Customer Service Bulletin

Product:	Welch Allyn® Service Tool		
Subject:	Software Release Notes v1.10.1		
HW Version(s) Affected:	All	SW Version(s) Affected:	All
Serial Numbers Affected:	All	Lot or Date Code Affected:	N/A

Figure 1 - WAST 1.10.0 SureTemp Test

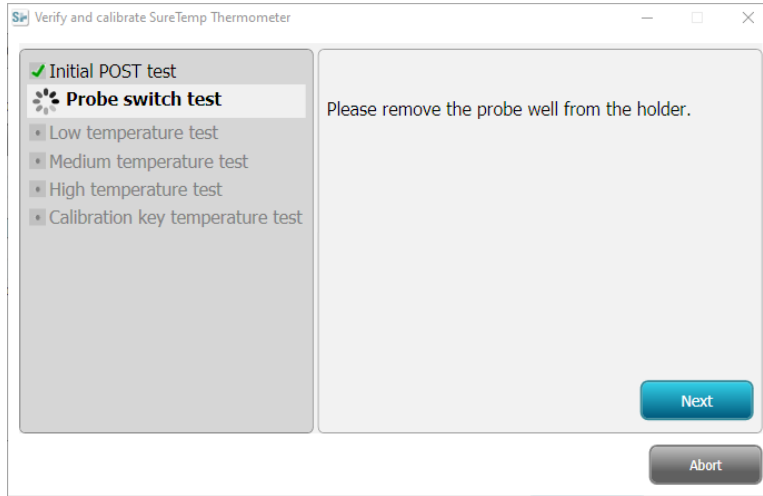
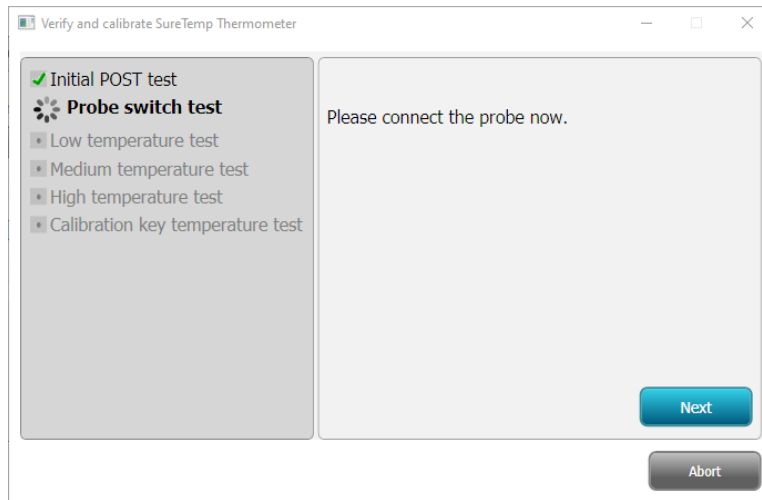
This release supports current and previous editions of the temperature module. Changes for this version are within the Verify and calibrate tab the following instruction has been removed for the SureTemp thermometer (as seen in previous versions)—

Now the verify test jumps directly to reconnecting the temperature probe—
